CENTRAL BUREAU (120-5-18-8) S.G. Building Construction - Working Projects - Meeting halls - covering over FDR Drive - 02 Nov 1951
Fuller-Turner-Wash-Statting in

Re: Contract HQ 1/75 - Meeting Halls
and Cover Over East River Drive
Punch List No. 2

N. C. # 87 Buildings: MEETING HALLS & COVER OVER EAST RIVER DRIVE

3 M-97 5 Nov'51 Layout & Dimen. of Cabinet & Equip. Sect. J etc.
(APPROVED 6 Dec 1951 JTA)

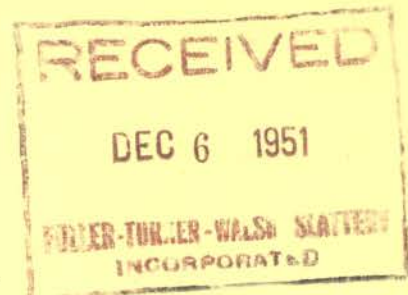
We are submitting for your approval six (6) copies of Edwards Company's drawing M-97, Issue No. 1, dated November 5, 1951, which covers layout and dimensions of cabinet and equipment for Section J of Fire Control Room. This panel is Lamp Annunciator for Air Conditioning unsupervised smoke, fire detecting and steam pressure reducing valve circuits for Meeting Halls and General Assembly Buildings.

"This drawing is approved."

3 H-1404 26Oct'51 Details of Section A in the Fire Control Room
(APPROVED 6 Dec 1951 J.T.A.)

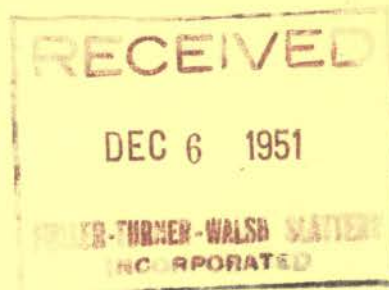
We submit herewith for your approval six (6) copies of the
following Cole Electric Products drawing:

"This drawing is approved."
